PHOENIX HOMES

NEWINGTON M – 2021

**Re: Proposed Single Family Dwelling, 108 Frank Fisher Crescent, Lot # 135 White Tail Ridge, Almonte,
Kollaard Associates File # 230020**

With regard to structural issues only, Kollaard Associates has reviewed the following drawings:

FOUNDATION PLAN (ALL ELEVATIONS)

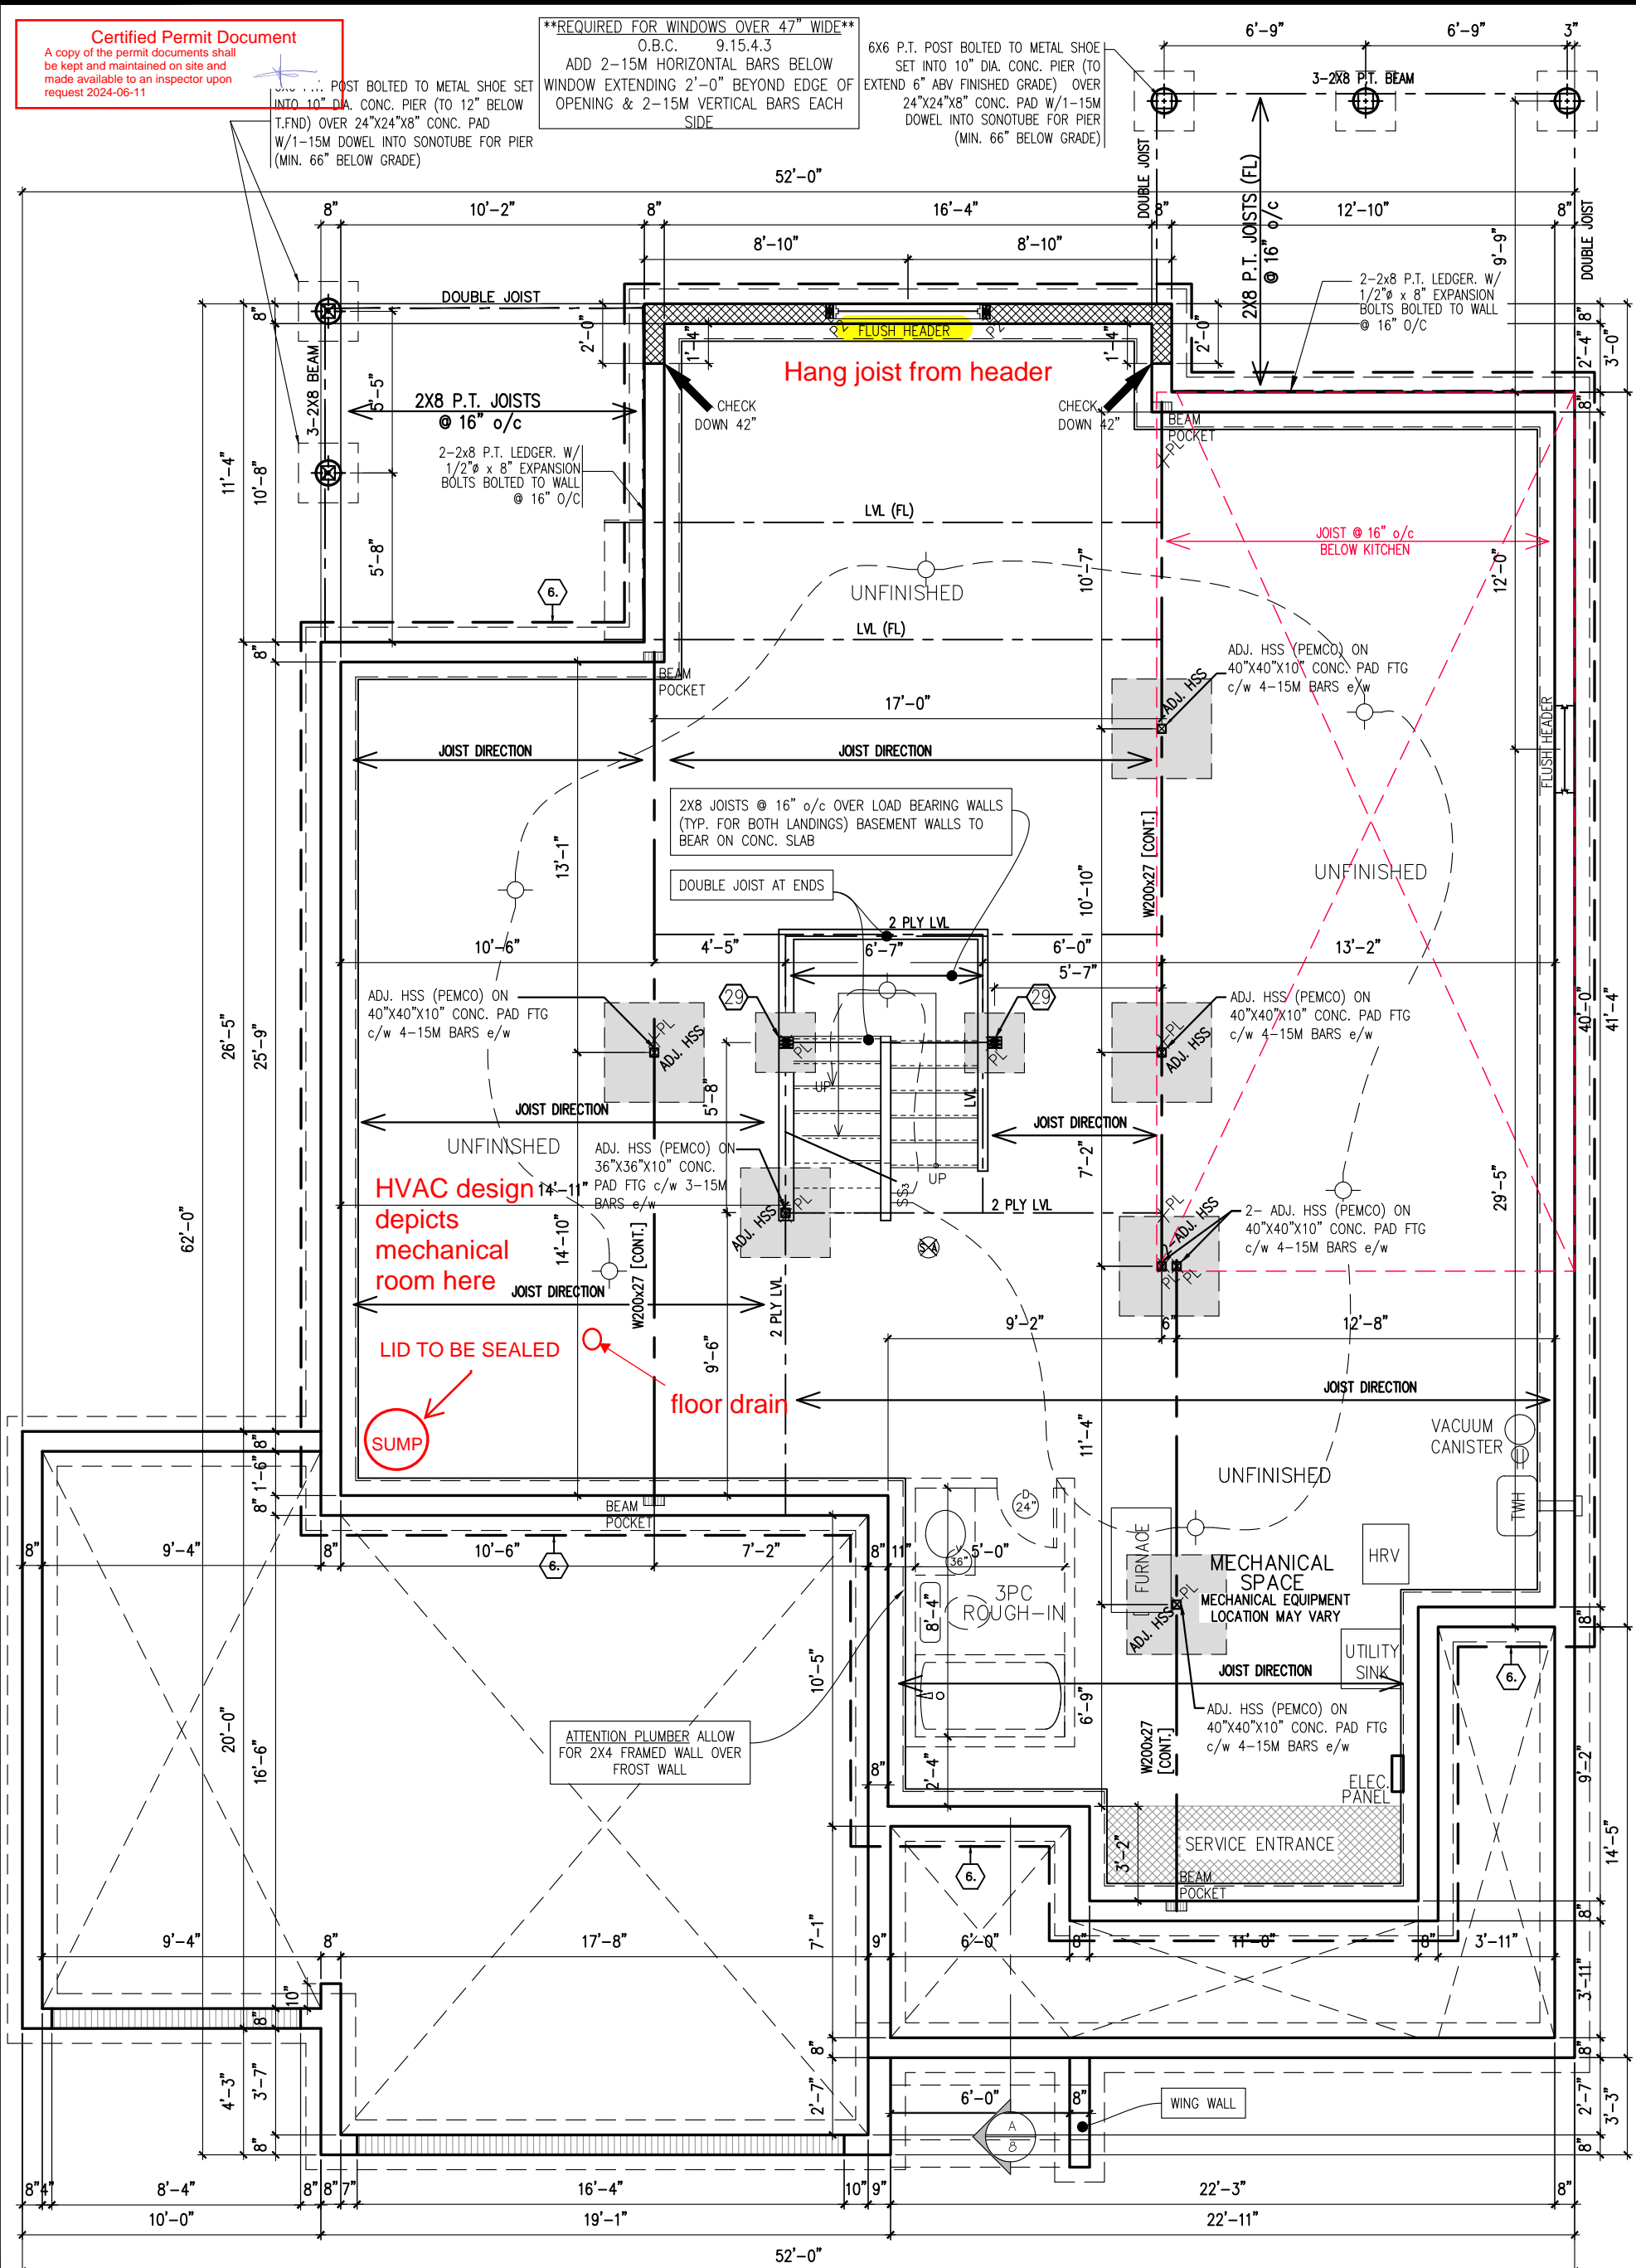
Basement Plan – Pages # 2M:

12. It is the opinion of Kollaard Associates that the proposed steel beams and posts shown on Phoenix Homes Sheet # 2M are adequate.
13. It is the opinion of Kollaard Associates that the proposed deck beams, posts, joists, sonotubes and ledger connection shown on Phoenix Homes Sheet # 2M and are adequate.

18. The proposed strip footings, interior pad footings and exterior pad footings shown on Phoenix Homes Page # 2M and noted on Phoenix Homes Sheet # 1M are adequate.

19. Floor joist design, flush LVL beams within the floor structure and LVL lintels are by the manufacturer. The posts supporting the flush LVL lintels shown on Phoenix Homes Sheet # 2M are adequate.

GROUND FLOOR PLAN (M ELEVATION)

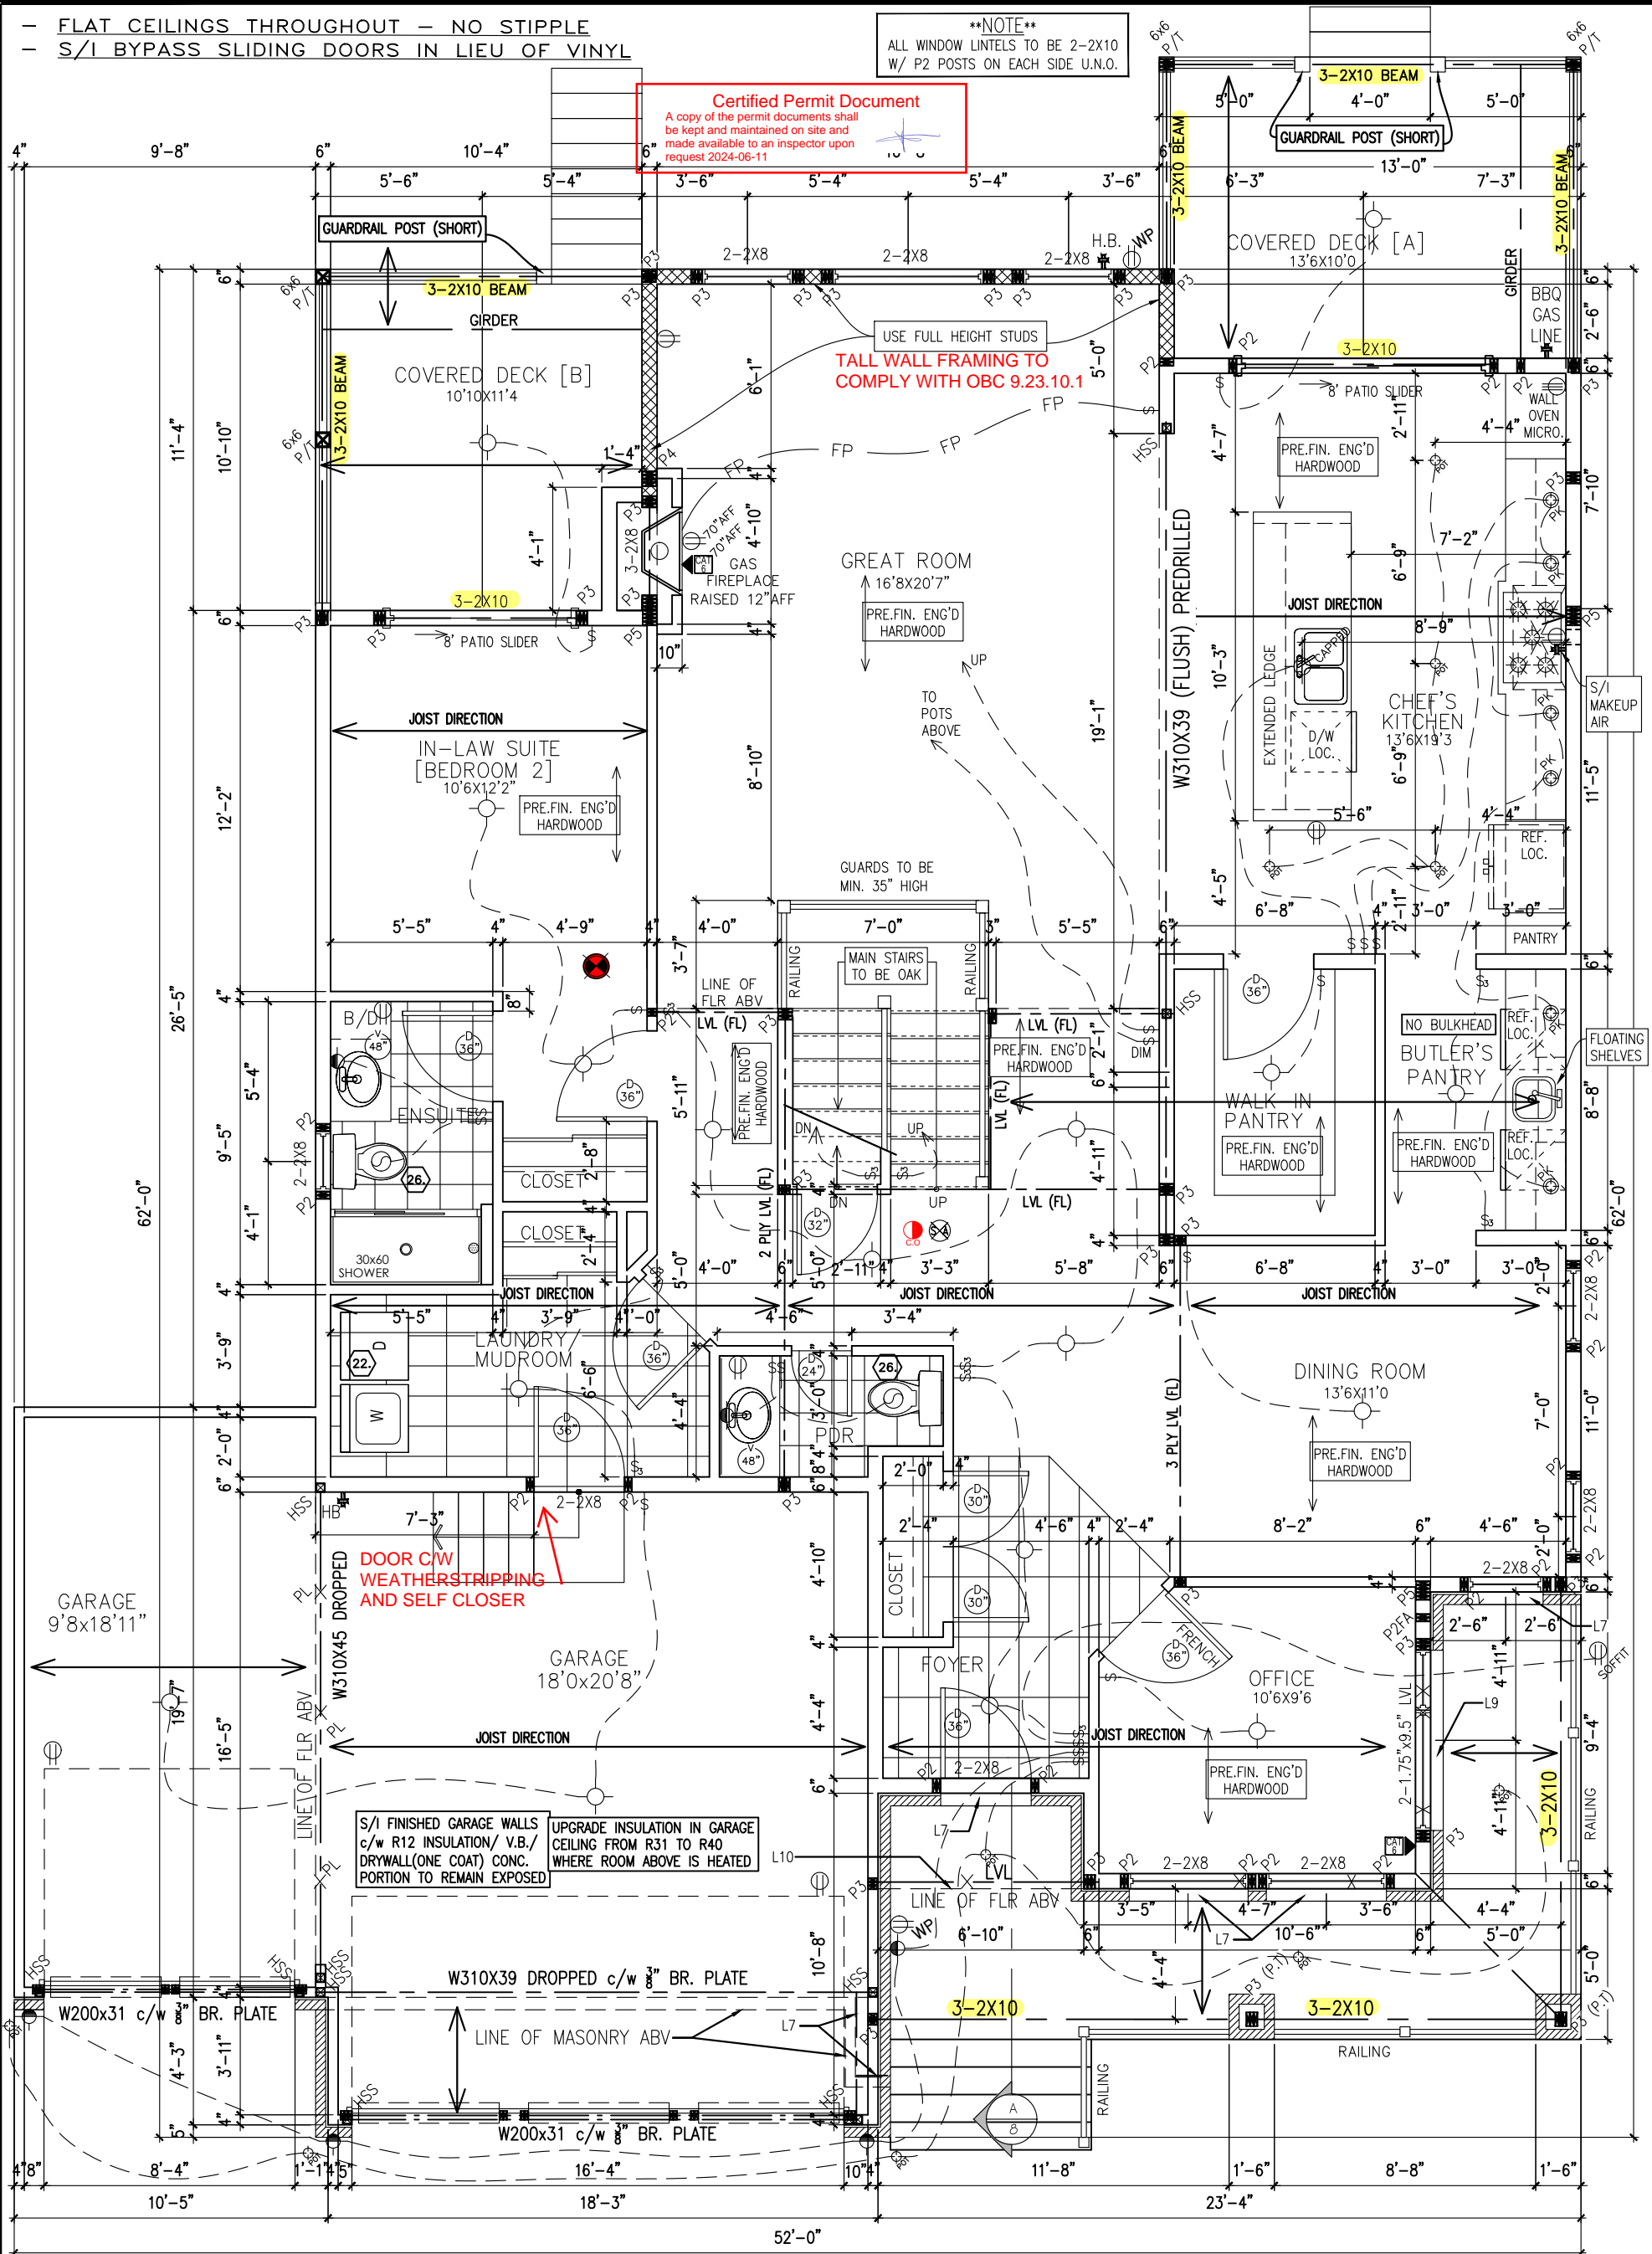
Ground Floor Plan – Pages # 3M:

5. It is the opinion of Kollaard Associates that the proposed lintels, beams and supporting posts shown on Phoenix Homes Pages # 3M are adequate

6. Ramset a 2x6 to the top flange of all steel beams to attach the above framing, floor joists and flush LVL beams.
7. The proposed web packing of the steel beam detailed on Phoenix Homes Sheet # 9M is adequate.
8. The proposed single angle connection of two steel beams detailed on Phoenix Homes Sheet # 6M is adequate.
9. Posts supporting girders may consist of built up 2x6 posts as indicated on Phoenix Homes Pages # 3M and are laterally supported by plywood or OSB sheathing (i.e. posts form part of sheathed exterior walls unless noted).
10. Truss design is by others.
11. Floor joist design and flush LVL beams within the floor structure are by the manufacturer.
